Hurricane Planning Commission Meeting Agenda

1. FSP23-68: Discussion and consideration of a possible approval of a final site plan for Buck's Ace Hardware, a commercial subdivision located at 1400 W 100 S. Buck Hurst, Applicant. Tyler Hughes, Agent.

STAFF COMMENTS

Agenda Date:	01/03/2024
Application Number:	FSP23-68
Type of Application:	Final Site Plan Application
Action Type:	Administrative
Applicant:	Buck's Ace Hardware
Agent:	Tyler Hughes
Request:	Approval of a Final Site Plan
Location:	1400 W 100 S
Zoning:	HC
General Plan Map:	Commercial

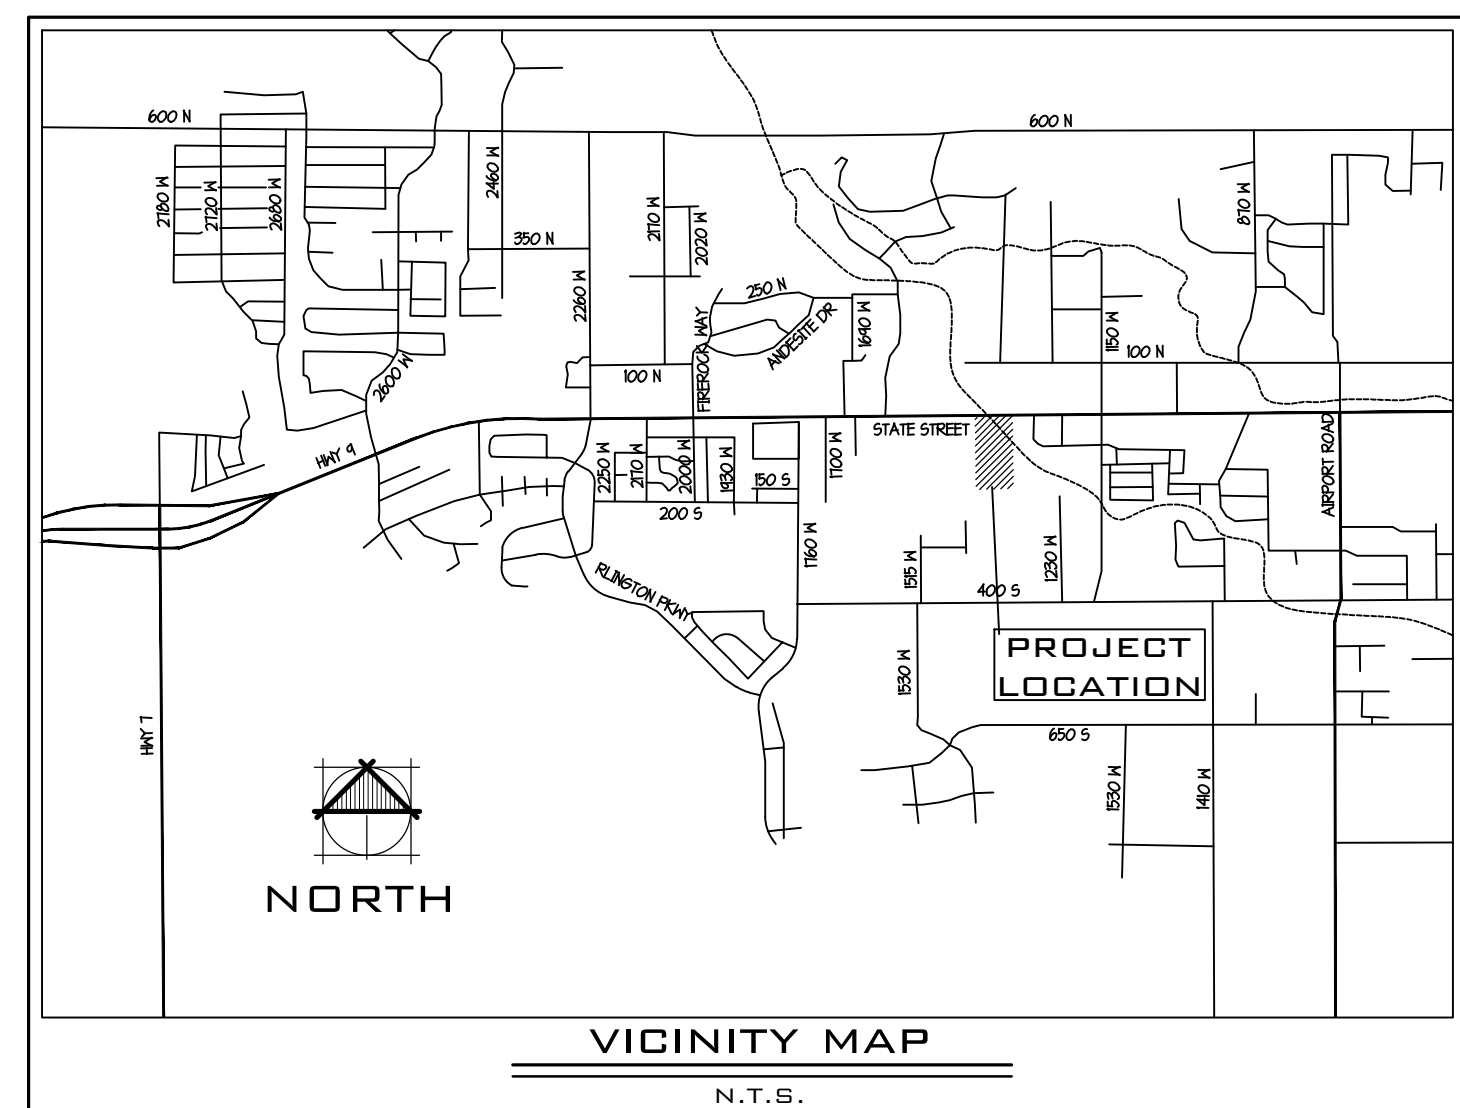
3. They are proposing 199 parking spots, per the code approximately 350 parking stalls are required

- a. The applicant has submitted a parking study prepared by Avenue Consultants showing that based on the parking needs of their current location and similar restaurant locations only 179 parking stalls are needed. The Planning Commission can approve a parking modification under the below code:

- xvii. Hardware stores often require less parking than similarly sized retail establishments like grocery stores or department stores since many customers are contractors or similar tradesmen who run in, grab what they came for and leave. Studies have shown that people spend far less time in hardware stores than grocery stores or department stores.

BUCKS ACE SITE
PLANTING PLAN

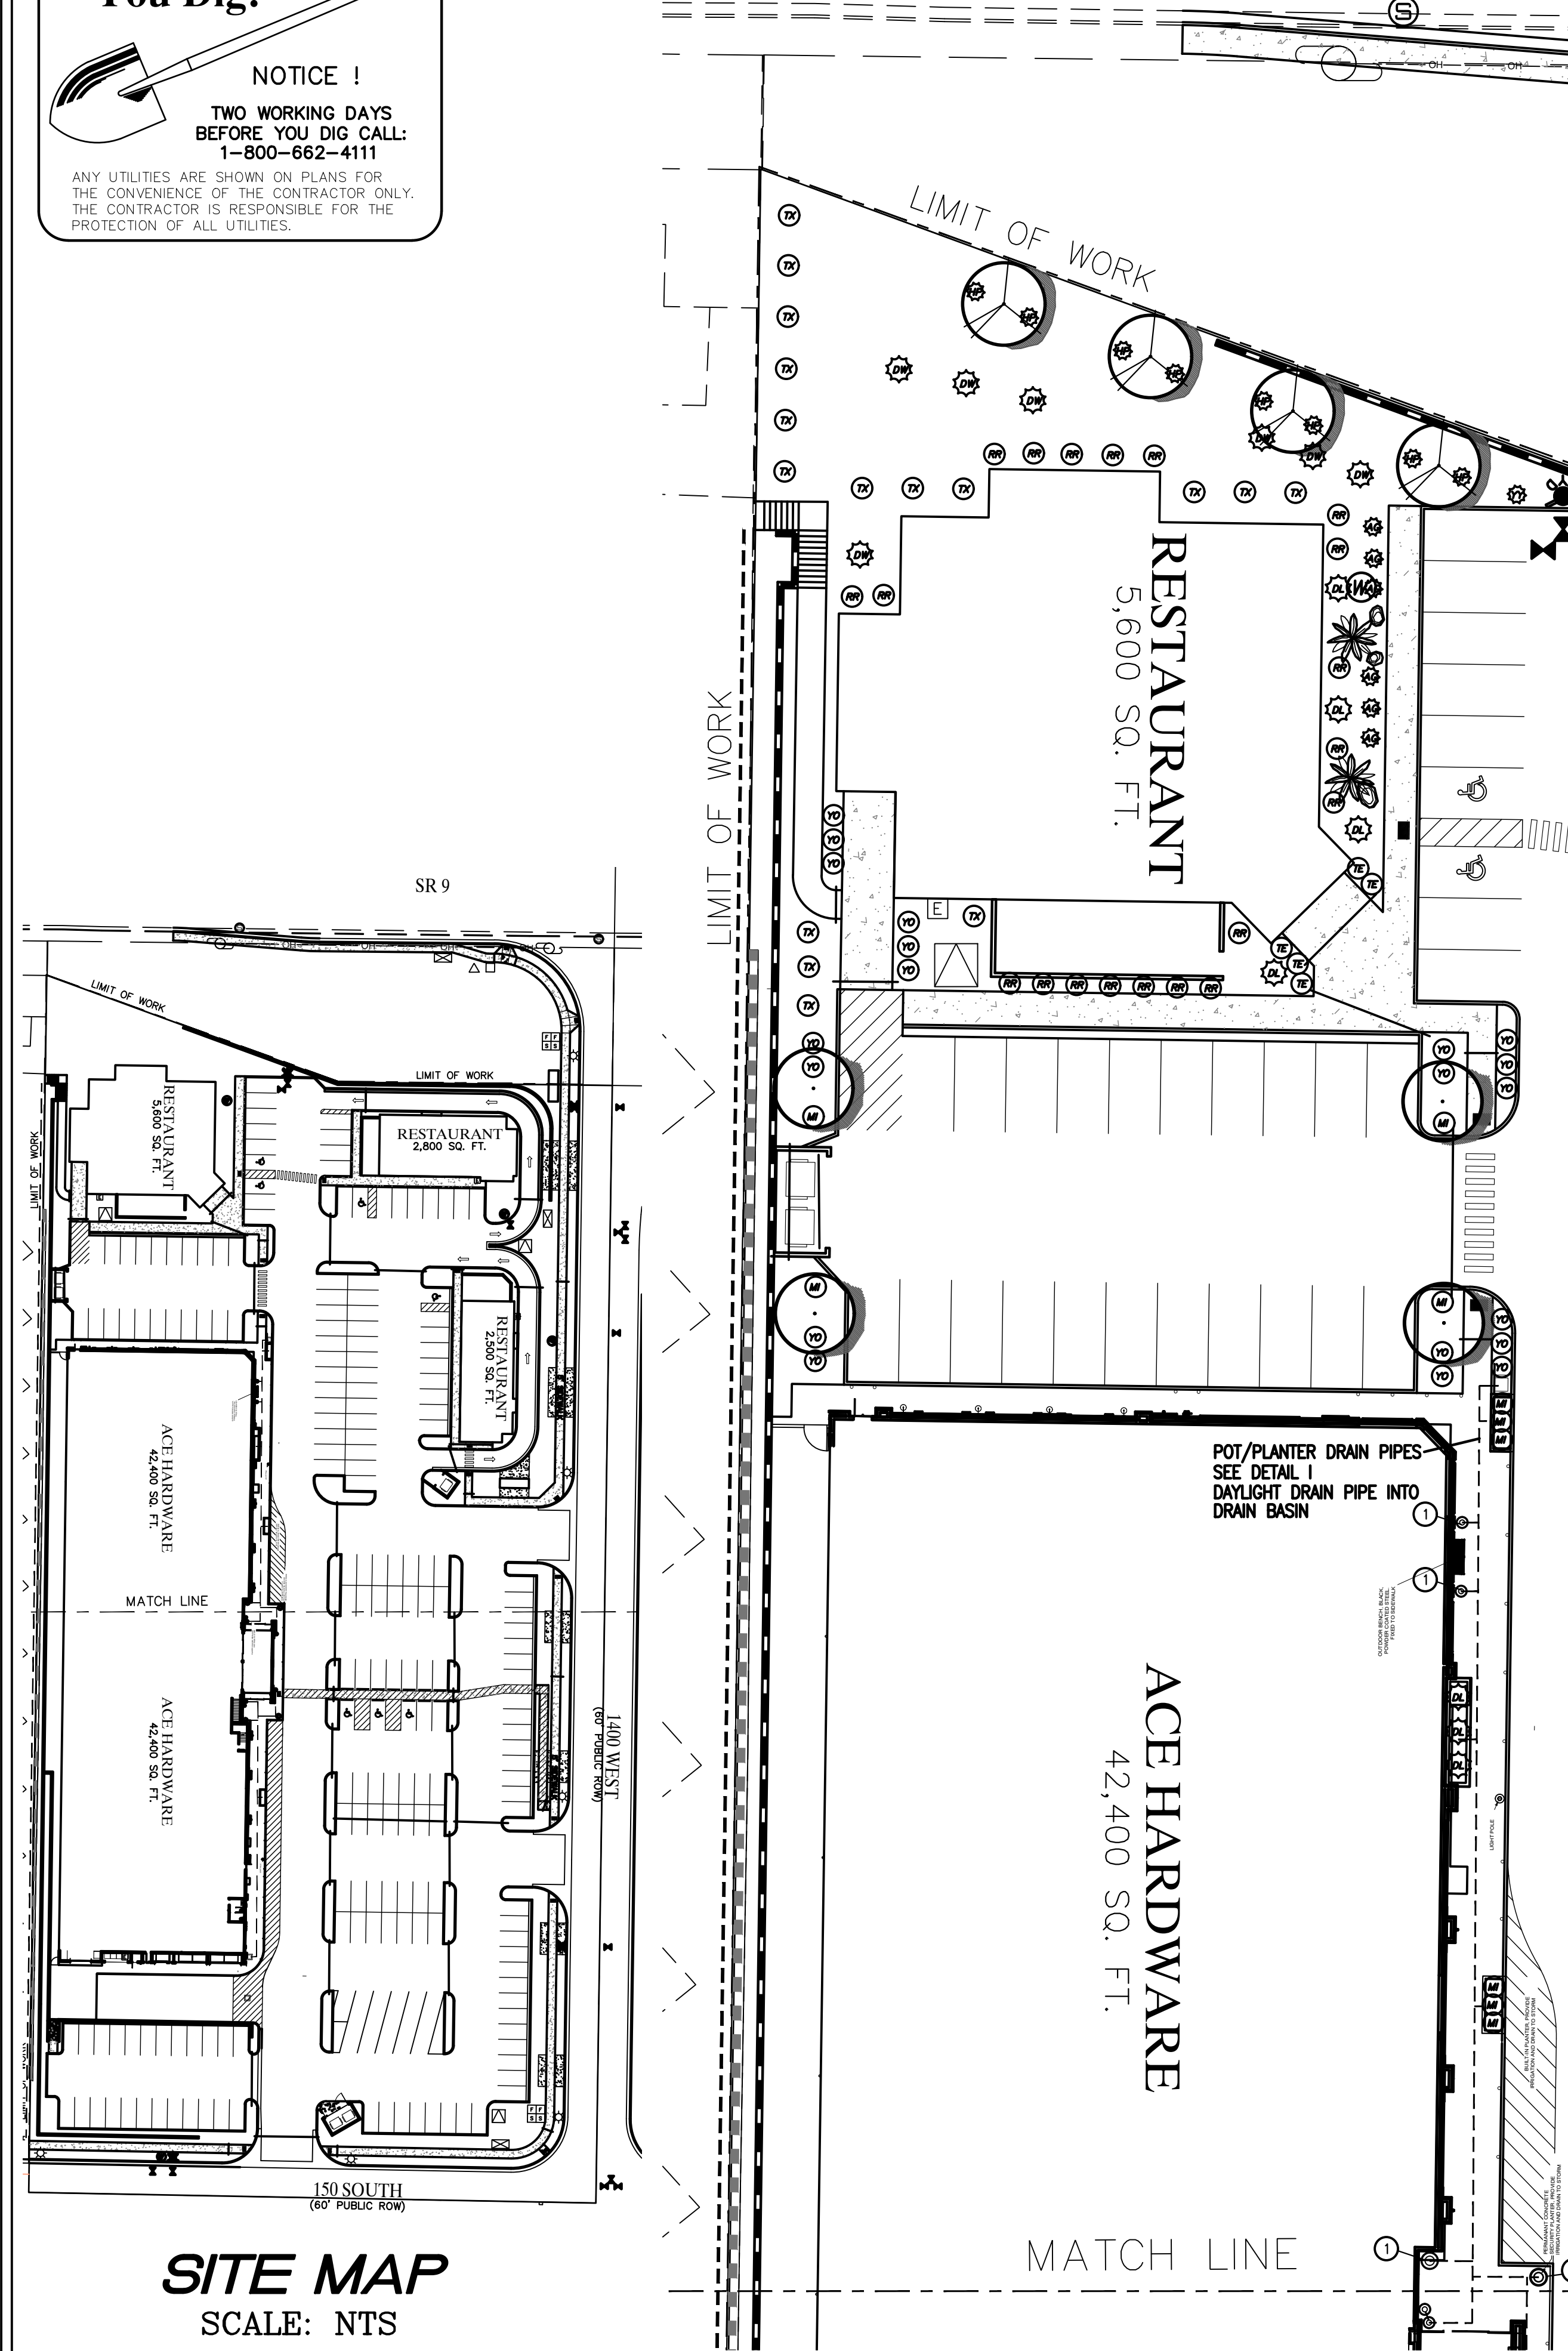
- 4. Landscape: The proposed landscaping plan meets Hurricane City Code. Staff would recommend some light landscape work be done on the UDOT property between this site and SR-9 for beautification reasons however this is not required.
